ARCHITECTURAL REVIEW BOARD REGULAR MEETING AGENDA

Agenda Item: **APPLICATION FOR NEW CONSTRUCTION, ARB #25-001, to consider an application for the construction of a new restaurant, Pollo Campero, with a drive-thru, located at 1131 Elden Street, Herndon, Virginia.**

Subject: Architectural and Urban Design Review of 1131 Elden Street, Pollo Campero

DRAWING TITLE:
REVIEW ELEVATIONS

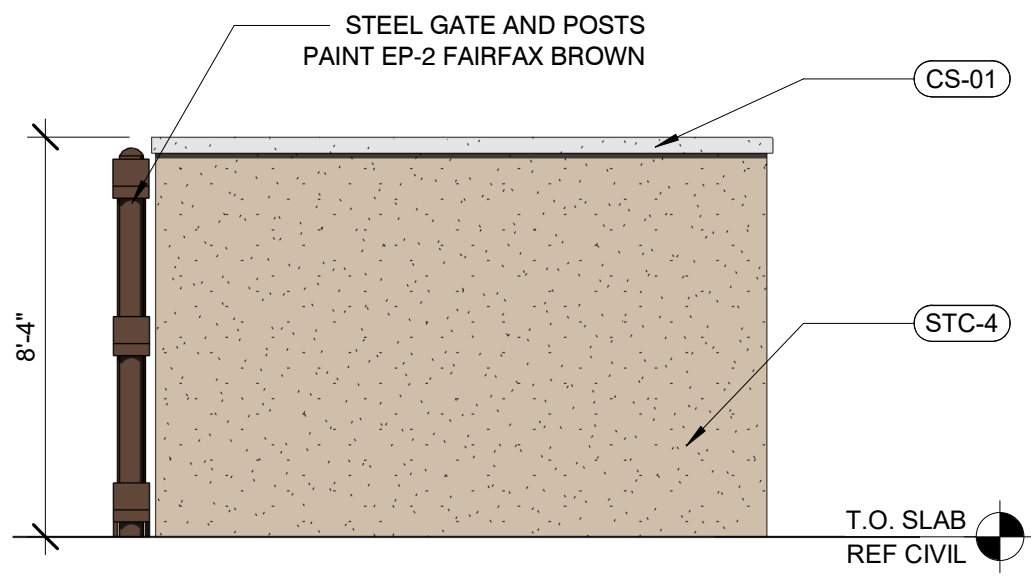
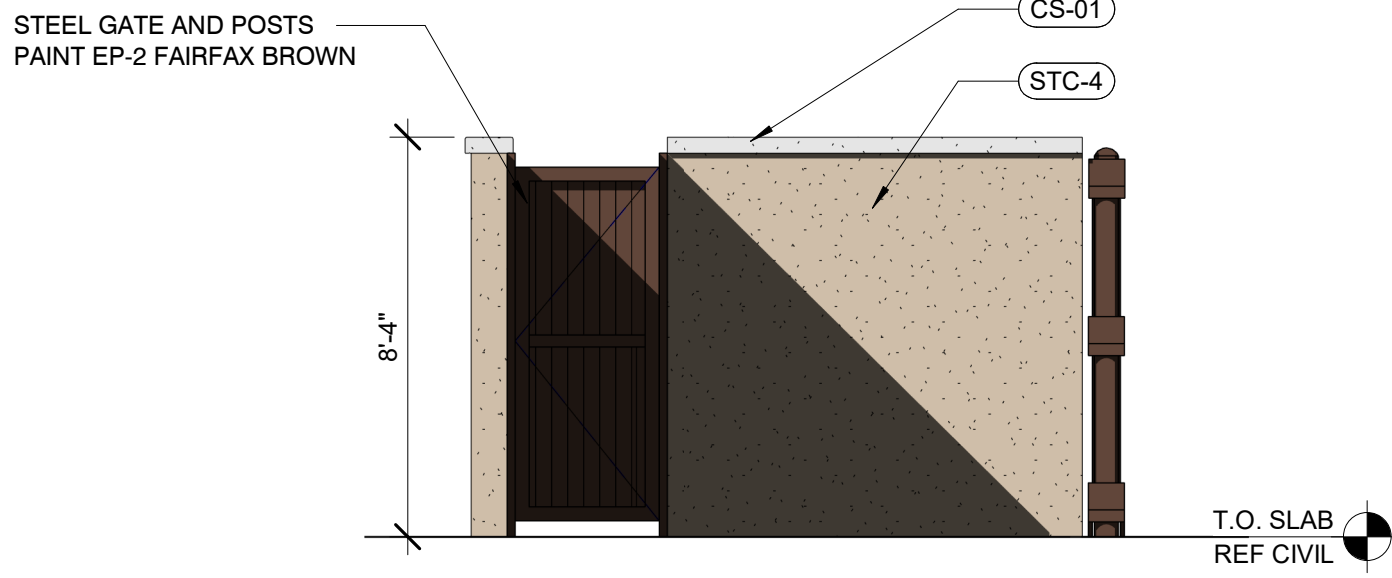
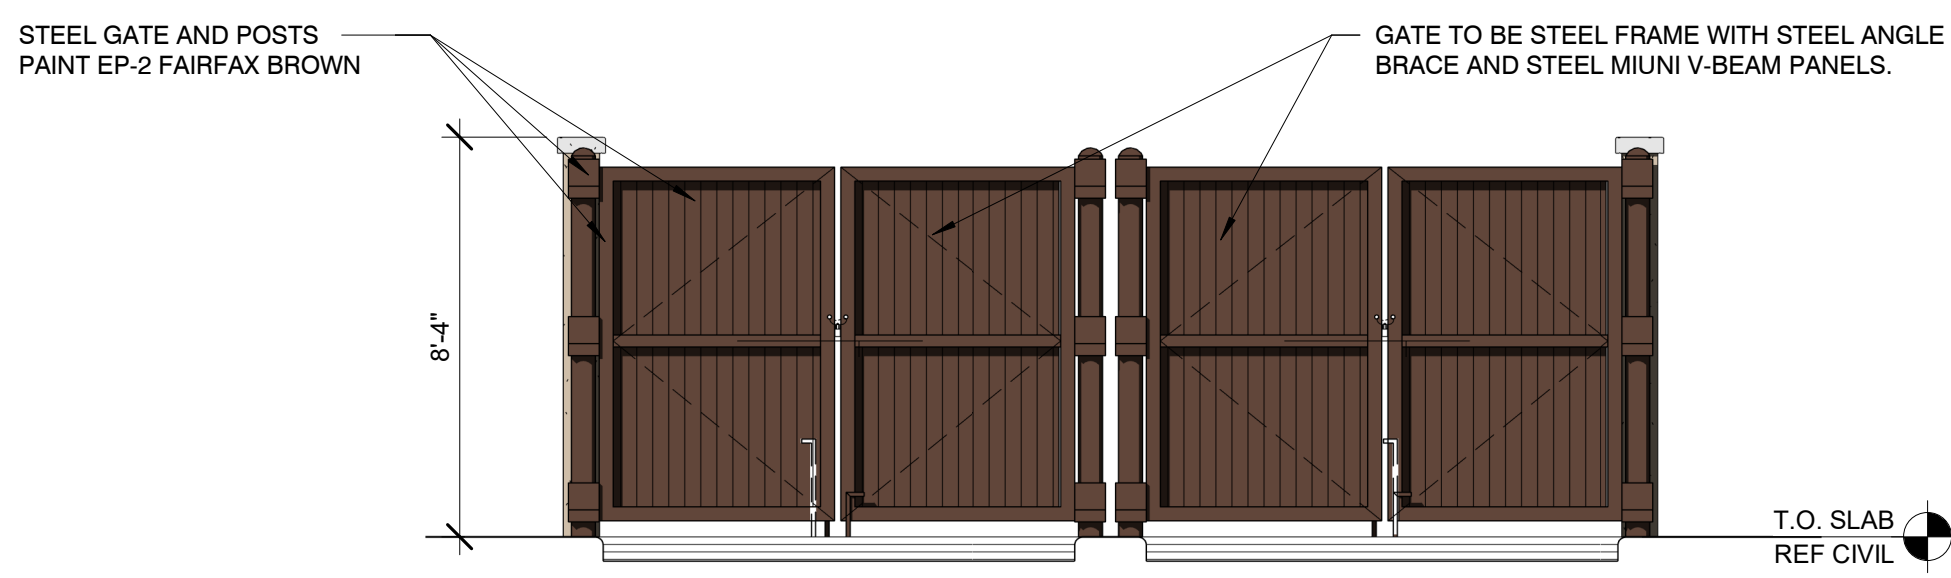
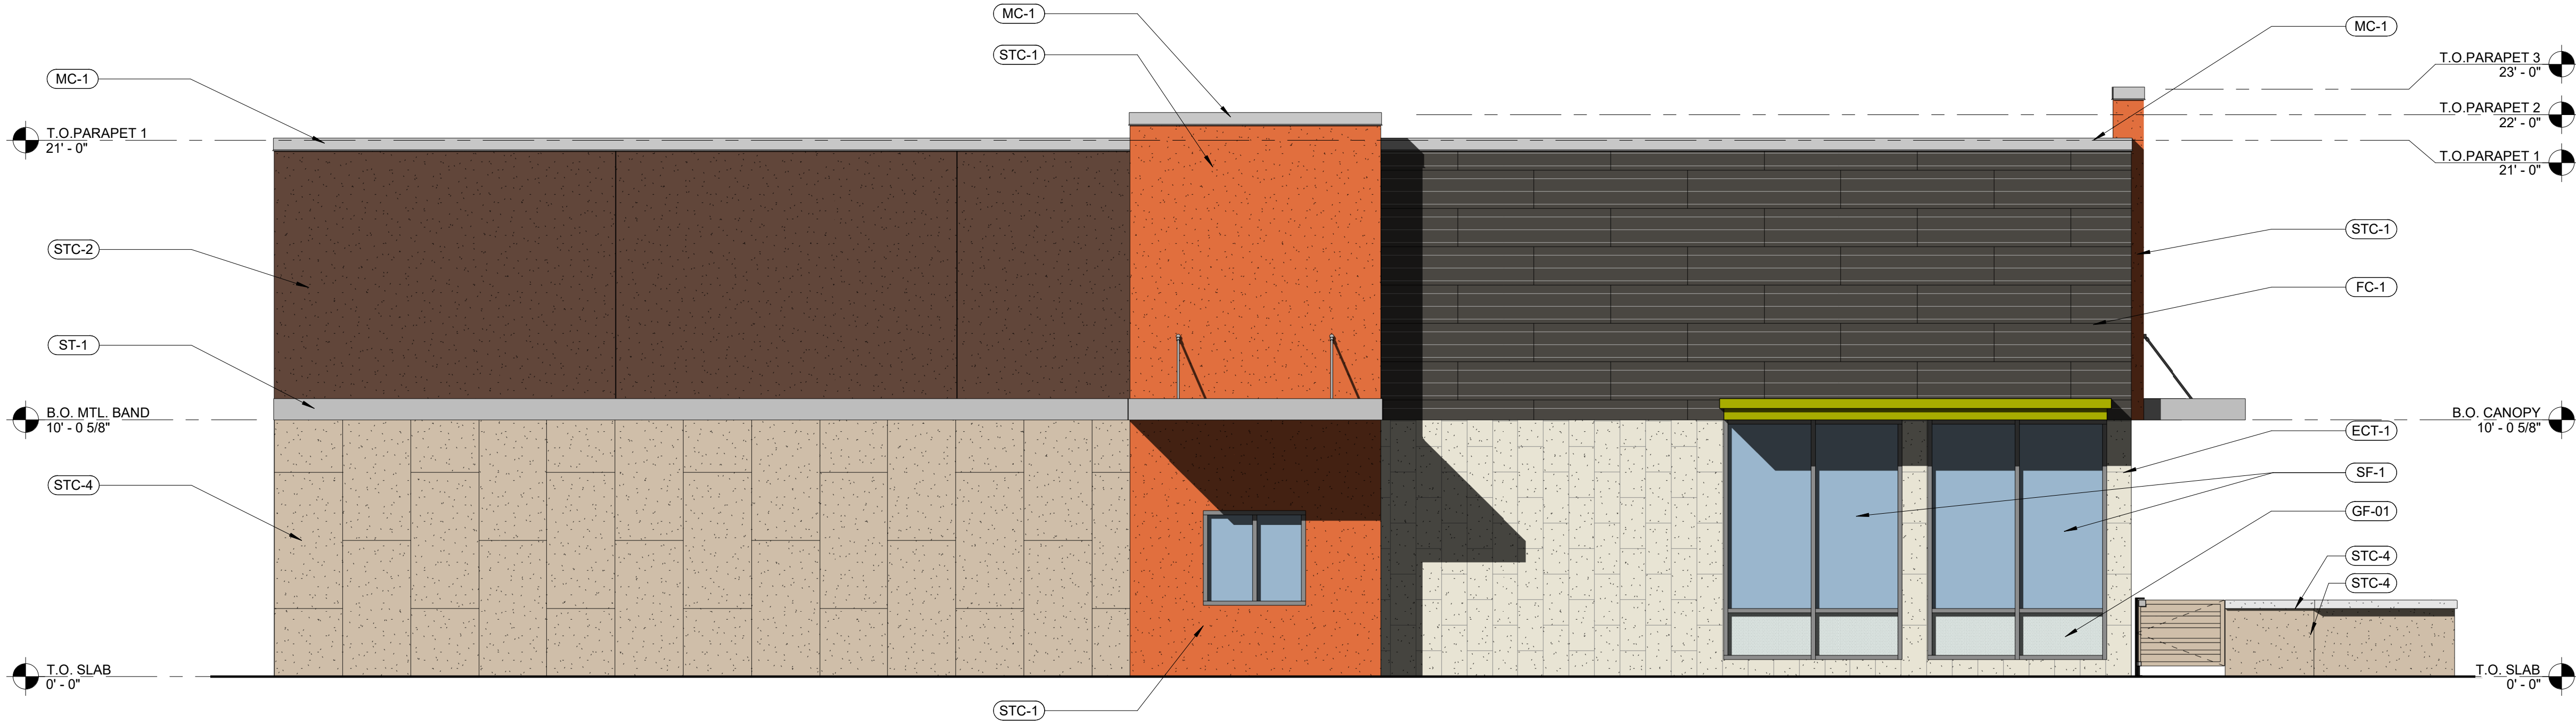
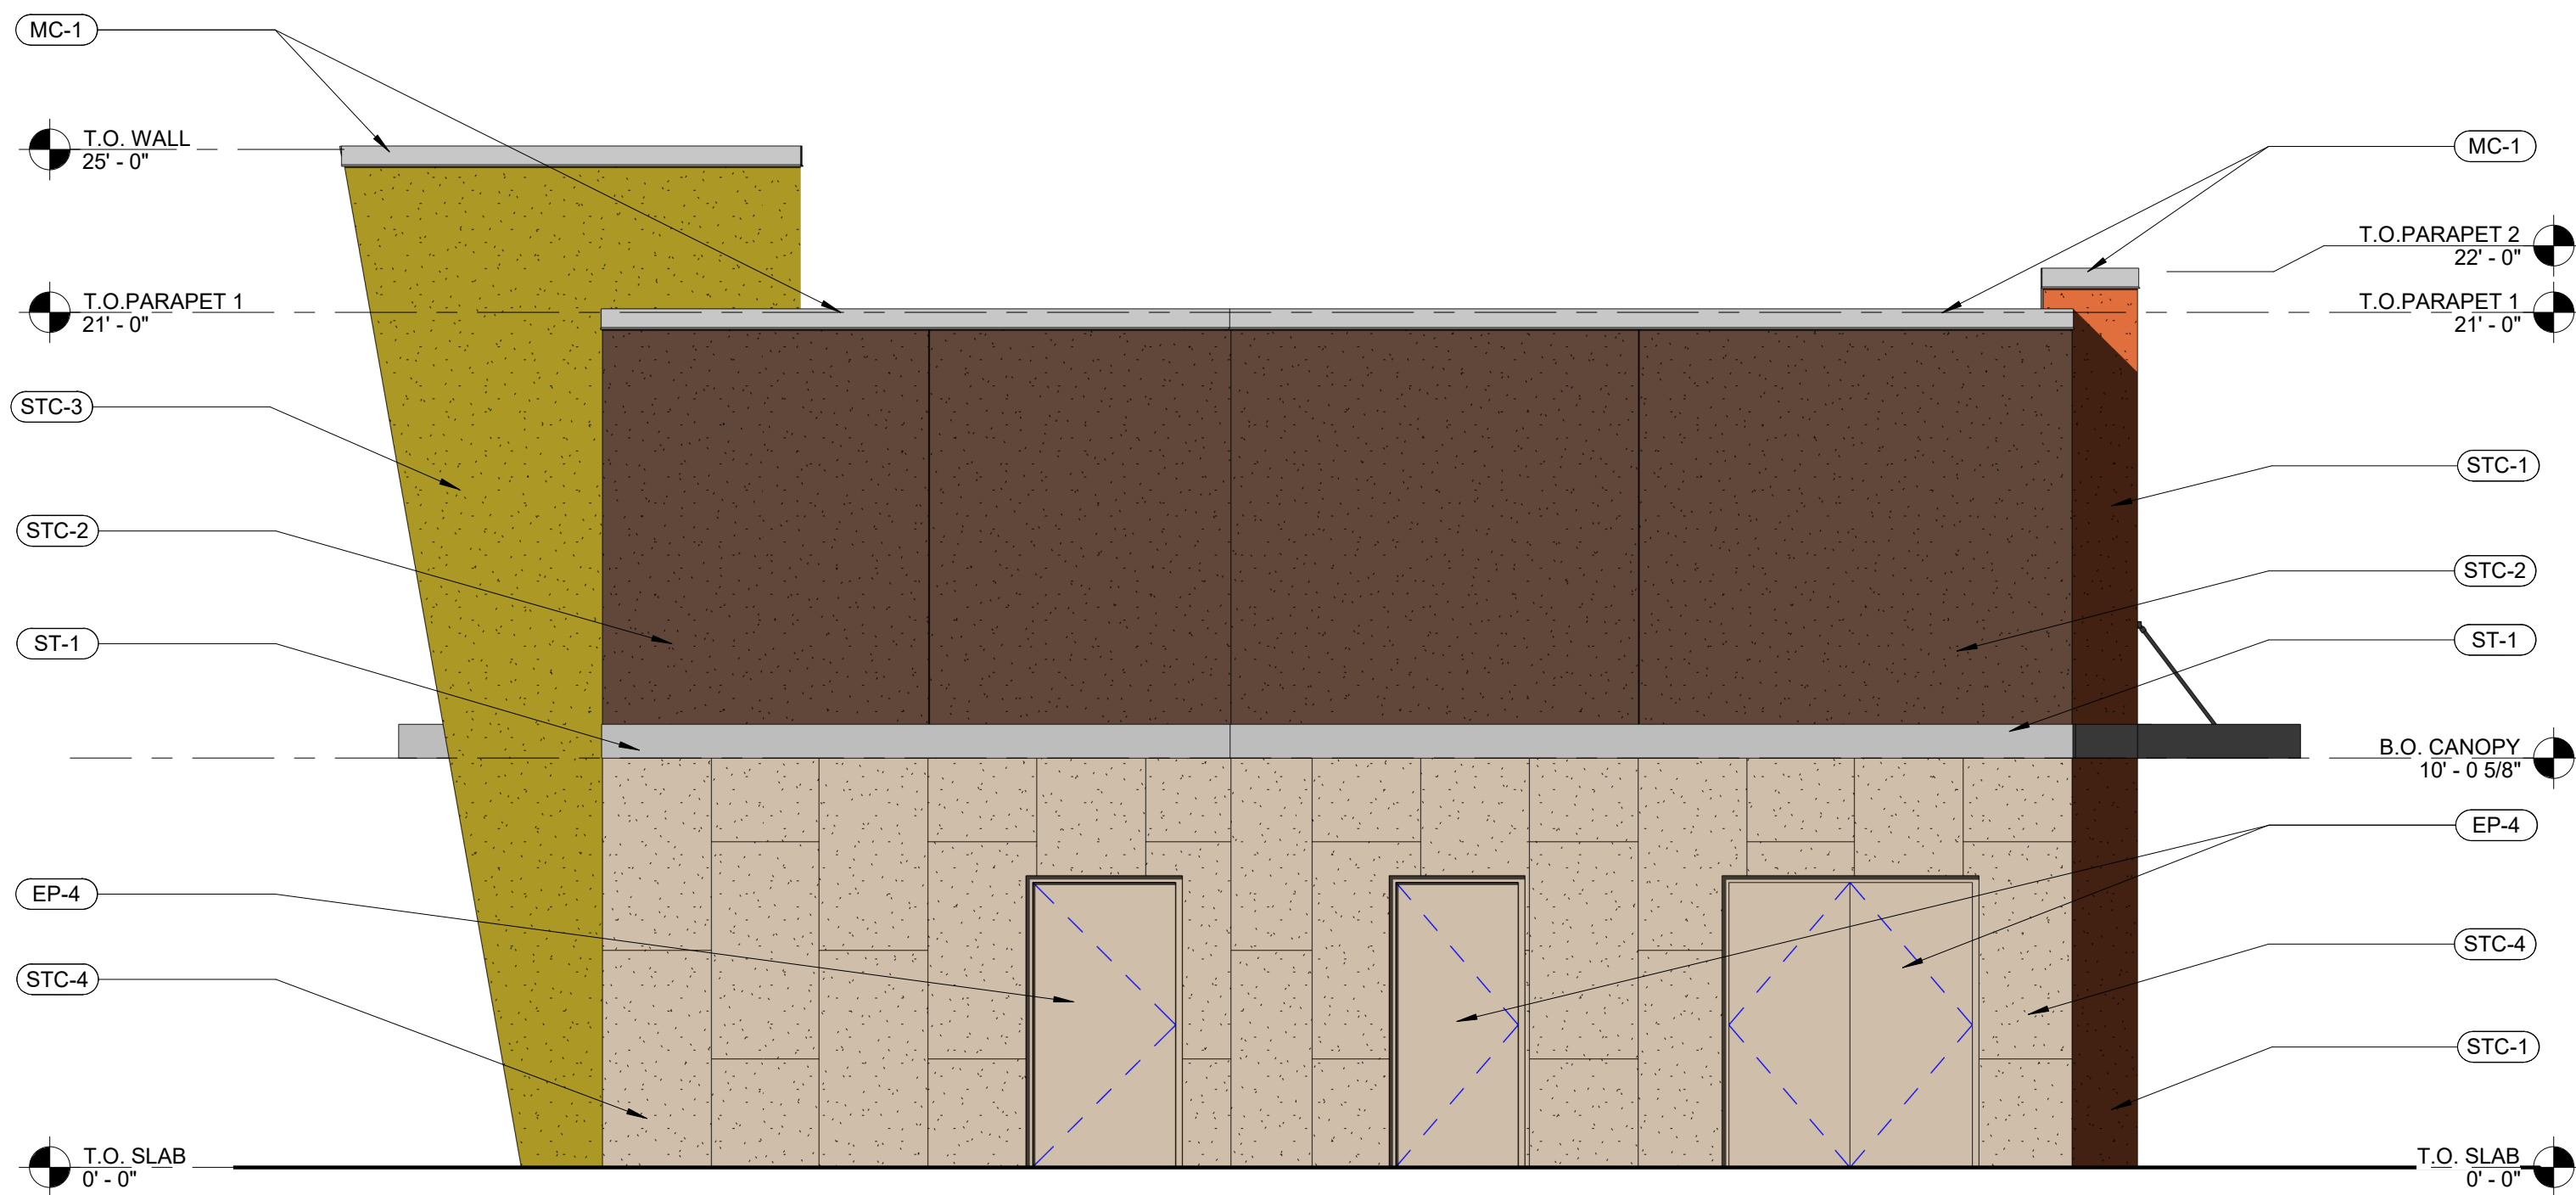
1. Over-reliance on Corporate Architecture and Architectural Trends. This design relies heavily on off-the-shelf corporate design intended to brand the architecture as an extension of the business' image and advertisement. The design is also reliant on current trends in design to include the simple rectangular shape, flat roof, and massing management handled mainly with changing cladding materials and shallow reveals rather than changes in wall planes. The ARB should be managing and mitigating these design tendencies in its review and guide the design in a manner that is unique to Herndon and represents thoughtful, context-sensitive, and timeless architecture, with durable and traditional materials. Staff recommends that the board strongly consider the overall design narrative and intent and have a discussion on whether and how the design can be re-thought with more of an emphasis on a uniquely Herndon design profile based on established architectural contexts or preferred future contexts.

2. Exterior Materials and Colors. The last design standard for the Architectural Control District states that buildings should not be designed to serve primarily as an advertisement of commercial display or exhibit exterior characteristics likely to deteriorate rapidly or be of temporary or short-term architectural or aesthetic durability. This standard should be carefully considered by the board. The use of corporate colors in such a dominant manner on the building is at odds with this guidance, as is the use of the synthetic stucco system as the primary cladding material. Materials such as brick and other masonry units, clapboard siding, or vertical siding, which can be applied in both traditional and contemporary forms, would be better options to consider. Corporate colors should be limited to signage and outdoor seating umbrellas. See Comment #2 in the attached 2021 staff memo.

3. Diversity in Exterior Materials. The design includes a variety of exterior materials and colors. Staff has requested that materials samples be provided for the work session. The overabundance of exterior materials creates an overly complex design. Fewer materials should be used to simplify the design and a clear hierarchy of materials between field and accent materials would assist in organizing the design.

4. Facade Articulation. Creating notable breaks on the primary wall plane and roof plan can be appropriate methods for managing an over-simplified form and dealing with concerns of flatness and shallowness. This can be handled with large windows with maximized transparency and accent forms that carry down to the ground. It is unclear from the provided materials whether the windows will be fully transparent. A sample should be provided. The accent tower appendage on the front facade is a concern and should be removed or substantially redesigned. Its floating condition above the entrance seems unnecessary and awkward. Its very shallow return above the parapet reinforces its disposition as an intended sign panel. Prominent architectural forms strictly made to contain signage should not be included in the design.
